Southern California Edison Company

January 21, 1986

Subject: Docket 50-206
Generic Letter 83-28 Item 1.2 - Post Trip Review:
Data and Information Capabilities
San Onofre Nuclear Generating Station
Unit 1

EVENTS RECORDER
PTS 21-40 DATE SEP 19 1985

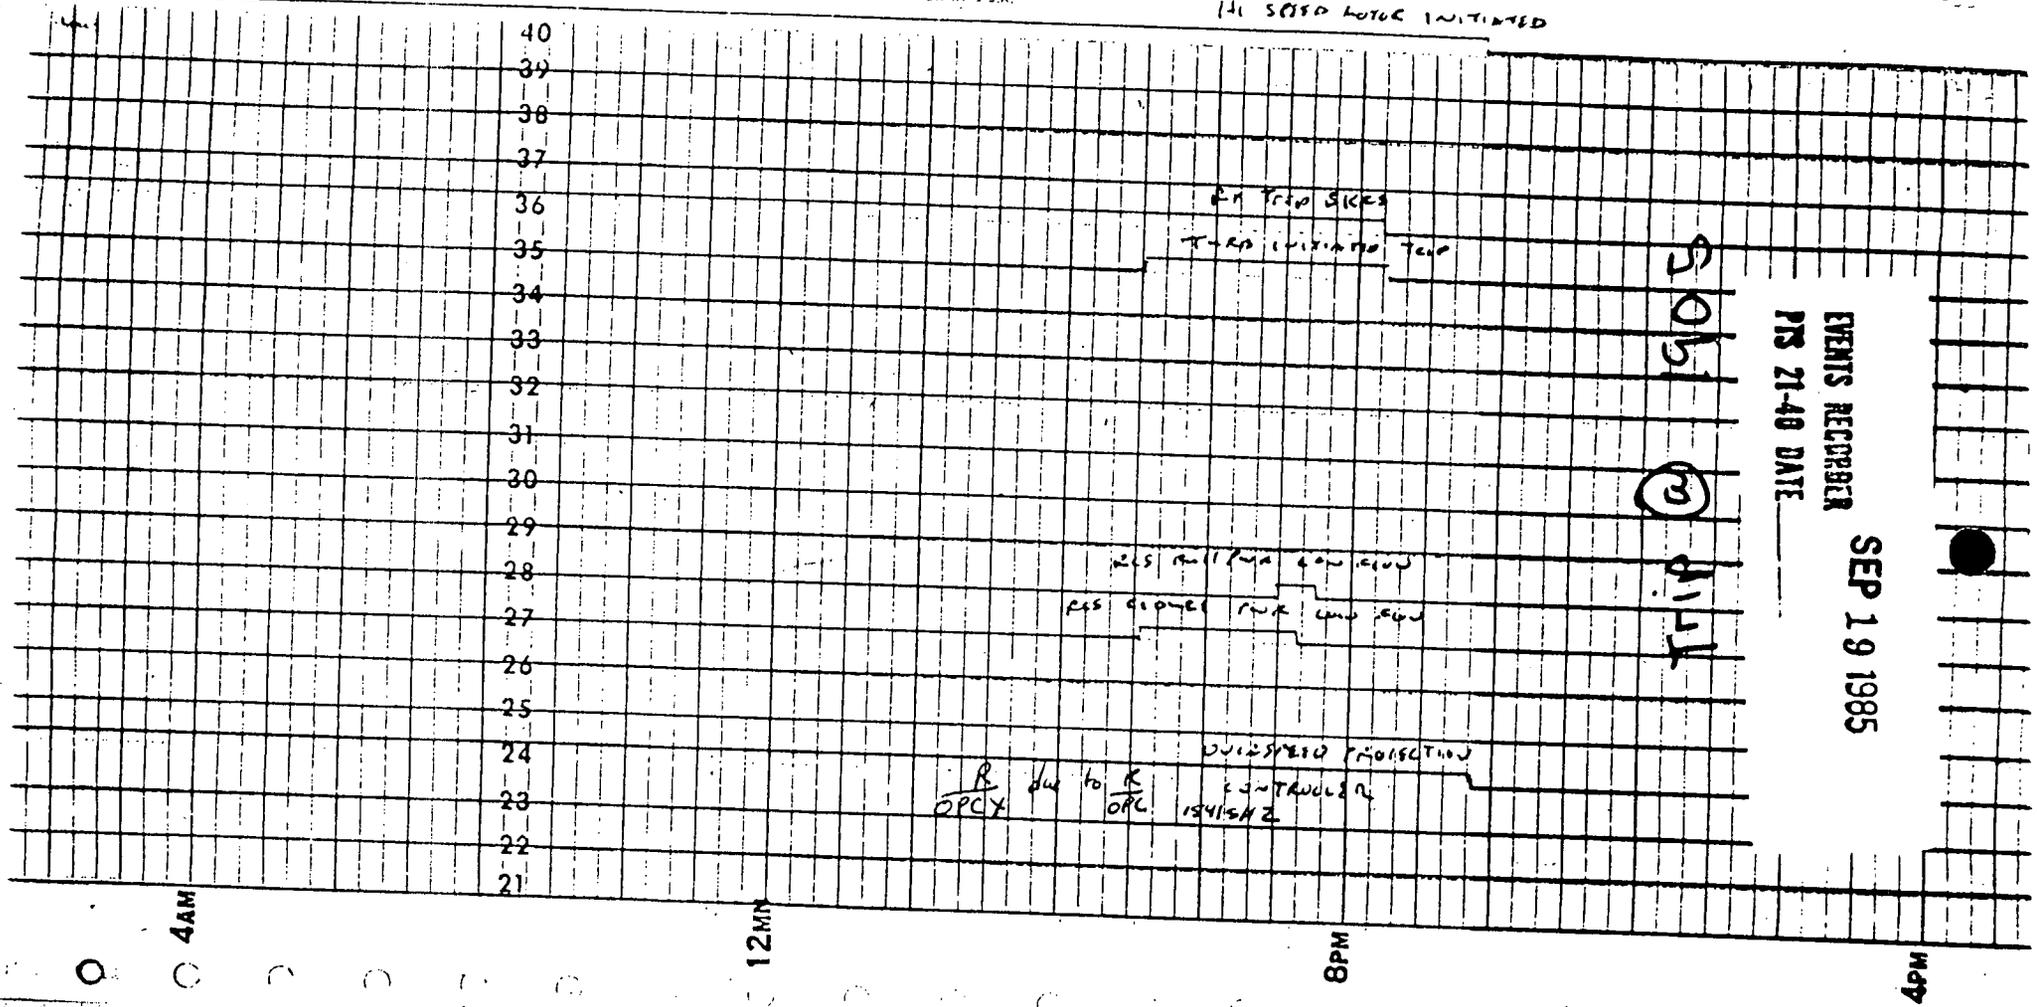
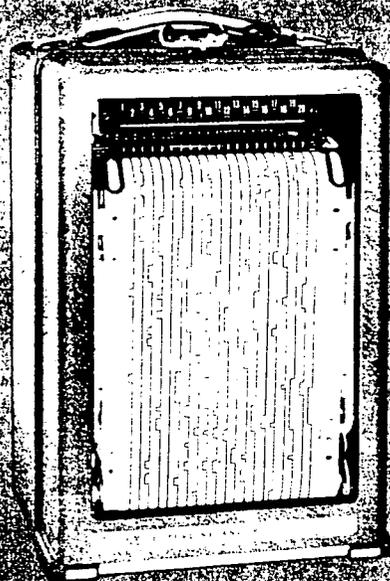
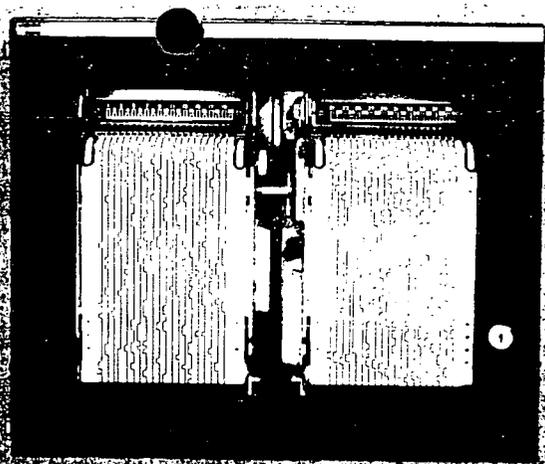
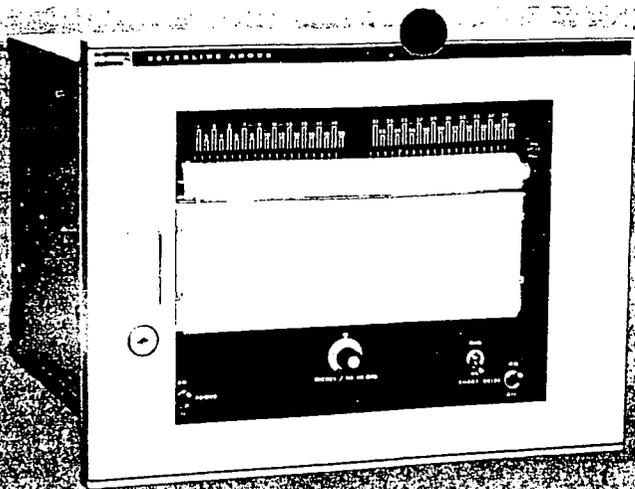
The staff reviewers also requested an explanation of the high speed operation of the Events Recorder strip chart. Our letter of November 28, 1983 indicated that on receipt of a trip signal the Events Recorder automatically enters a high speed mode of operation in which the strip chart is advanced at 3600 times the normal speed for ten seconds. Subsequent review of the strip chart operation has indicated the chart will advance at 3600 times normal speed (3/4 inch/sec versus 3/4 inch/hr) for 24 seconds, which is equivalent to a 24 hour period of normal speed operation.

CHART FAST SPEED 3/4 $\frac{\text{inch}}{\text{sec}}$
CHART NORMAL SPEED 3/4 $\frac{\text{inch}}{\text{hour}}$

RUNS FOR 24 SECOND
AND RESETS AFTER
24 hour. run (18 inches)
